CMEI Public Engagement Meeting RE: Proposed FRSC Crane Mountain Landfill Expansion

Crane Mountain Enhancement Inc.
EXP Services Inc.
March 19, 2024

Crane Mountain Landfill
3D Model of current approved height +90 m

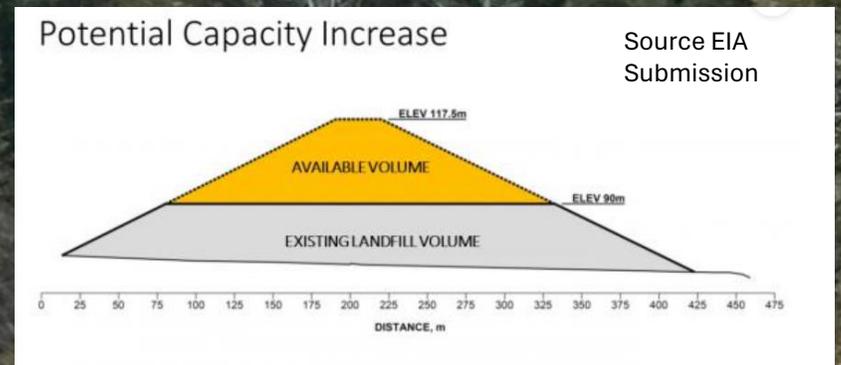
- Viewplane(s) –
 - The issue of viewplanes was a significant consideration in limiting the original allowable height of the landfill;
 - In CMEI's opinion the current EIA study viewplane analysis is inadequate.
- Socio-Economic – in CMEI's opinion the implications to the host community have not been adequately assessed, e.g.:
 - potential for constraint on expanding residential development(s) and consequently providing for additional tax base to maintain and enhance infrastructure;
 - Viewplane and odour limiting attractiveness of the community to newcomers;
 - Ongoing issues of odour and aesthetics.

Will an additional 27.5 m (>90 ft!!!) of waste height be very noticeable.....?

Key Model Findings of Study:

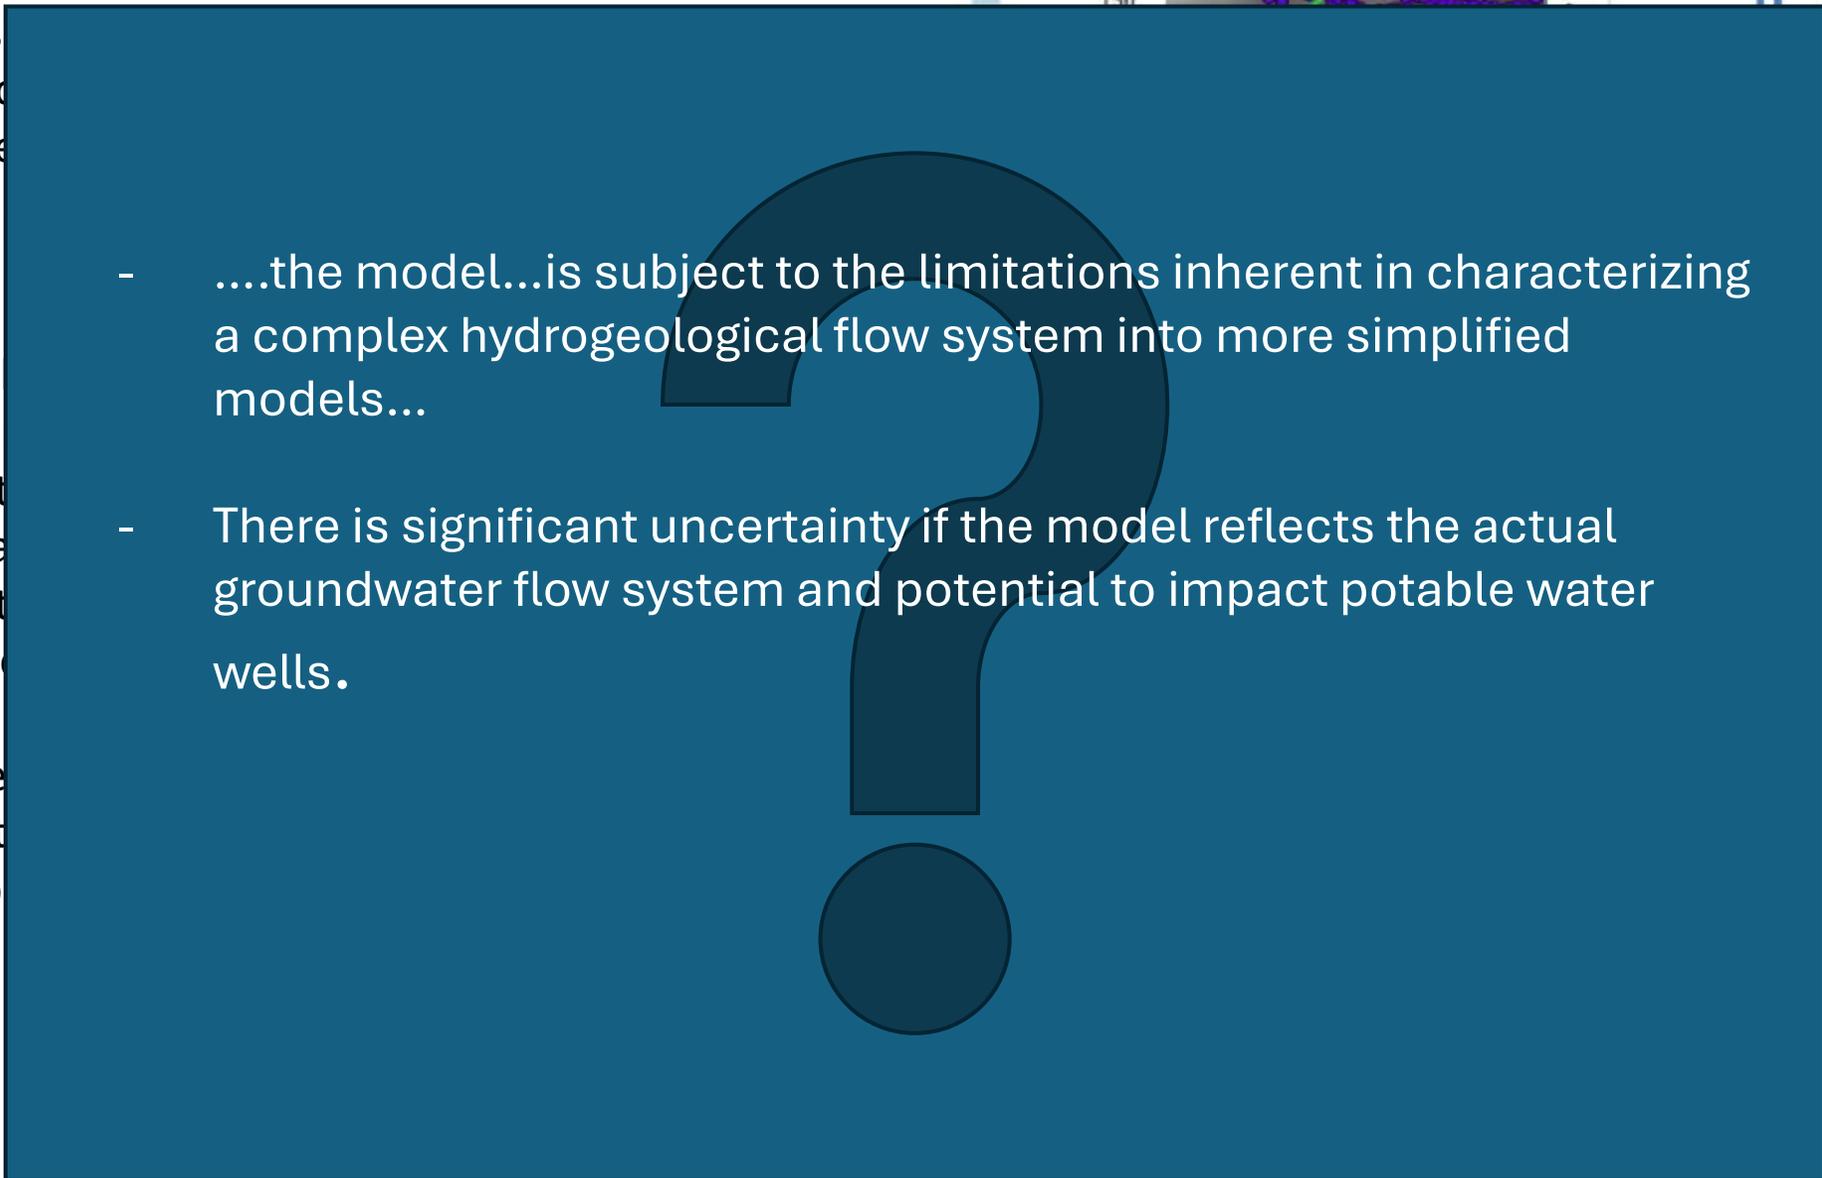
- ...the model...is subject to the limitations inherent in characterizing a complex hydrogeological flow system into more simplified models...
- There is significant uncertainty if the model reflects the actual groundwater flow system and potential to impact potable water wells.
